## **DELEGATED DECISIONS BY CABINET MEMBER FOR TRANSPORT MANAGEMENT**

### **SOUTH LEIGH: CHAPEL ROAD AND STATION ROAD – PROPOSED TRAFFIC CALMING FEATURES**

**Report by Director of Environment and Highways**

### Location 8

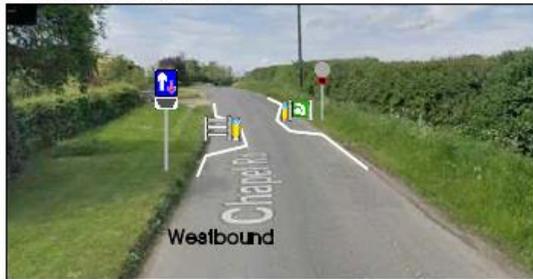
(19) Local resident, (South Leigh, Chapel Road)	<b>Partially support</b> – I do support traffic calming in South Leigh but am concerned about the proposed placement of the street furniture in Chapel Road. In fig. 8 the calming furniture is right outside my and my neighbour's properties, both grade II listed buildings. As both buildings are thatched I am worried about the possible obstruction of fire appliances to get to the water supply, should the worst happen. I also worry that getting in and out of my drive could be hazardous.

22. A number of residents raised concerns about the specific location of the proposed features, related to impact on their ability to access their properties, visual impact on setting of their property and proximity to nearby junctions, brow of hills etc. The proposed location of the features has been carefully considered and seeks to strike an appropriate balance between being effective in reducing vehicle speeds outside residential properties whilst ensuring accesses are fully maintained. Whilst no significant changes are proposed to the location of the features their final locations and dimensions of the chicane/gateway features will be determined on site should approval be given, with adequate clearance provided to accommodate agricultural vehicle requirements and residential property accesses.

### Location 11

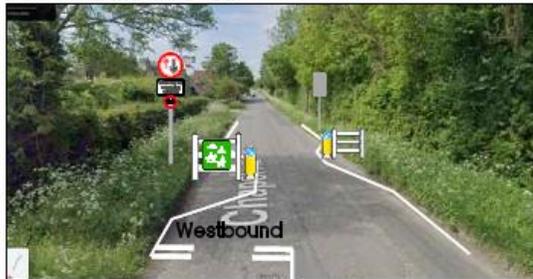
(28) Local resident, (South Leigh, Lymbrook)	<b>Partially support</b> – 11 and 18 ok. 15 is close to corner wont see vehicles until they round corner wrong side road rounding gate farm and lorry vehicles are long and slow moving .if you go from Church Hanborough to lower road the speed gate can cause a surprise if farm vehicle or lorry is through speed gate and still your side of road. 8 all as above blind hill top wet roads ice I think wrong place. The water that runs across road next to cottages before the hill may be a problem with vehicles running wrong side of road to avoid the water.

### Location 15

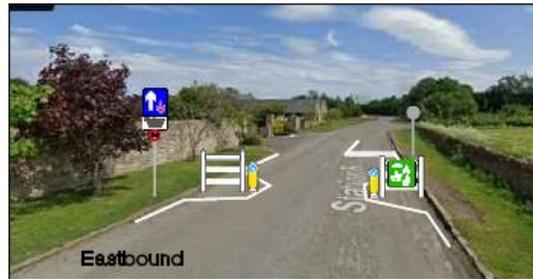
<p>(12) Local resident, (South Leigh, Station Road)</p>	<p><b>Object</b> – I object to Location 15 which is right outside my house. At that point the distance from the house to the kerb is narrower that further along or further back on that road. The proposed location is right where I have to position my car to reverse onto my drive, making that impossible if Location 15 goes ahead as currently planned. Getting on and off my drive would become quite dangerous. Also, it would not only affect my privacy but also be dangerous for my visitors (including very young children) to visit me, as well as creating a build up of traffic fumes when busy. Also,</p>

Location 15 is just past a bend which is a natural traffic calmer, so putting a traffic calmer at Location 15 seems a waste of time and money - it would be of more use further along the road where traffic tends to speed up.

(25) Local resident, (South Leigh, Station Road.)	<b>Partially support</b> – I'm a resident. The positioning of the calming measure on station Road close to my home at 1 Lymbrook cottages is in a terrible position. The bend is blind and traffic regularly passes at 40mph plus. Yes measures will slow it but between measures motorists pick up speed. The village is used as a cut through. A short cut. People are short on time. They don't do 20mph. The positioning here is dangerous. I believe positioning on a straight piece of

road some 100 metres closer to the pub on the same road would be better. More visibility and less of an eye sore for residents where the measure will be placed. Personally I see no advantage to calming chicanes. If we are to have them though, I would suggest a change in placement as above.
